**Service Bulletin**

**SUBJECT: UNIT POWERS OFF DURING PLAYBACK OR RECORDING**

**MODEL (S): MZ-R3**

**MT-MZR3-109**

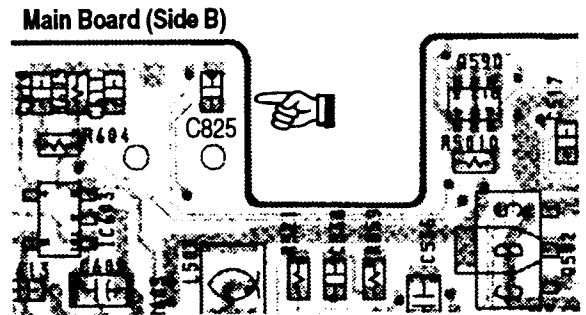
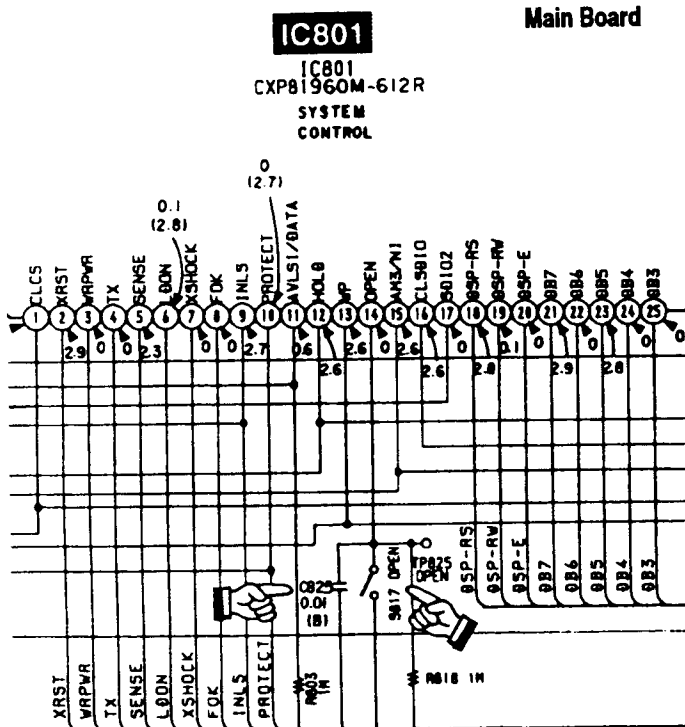
**CAUSE:** Failure of the Open/Close Switch S817.

**SOLUTION:** •Replace the Open/Close Switch S817.

•Replace the 0.01 $\mu$ F Chip Capacitor C825 on the Main Board with a 0.22 $\mu$ F Chip Capacitor.
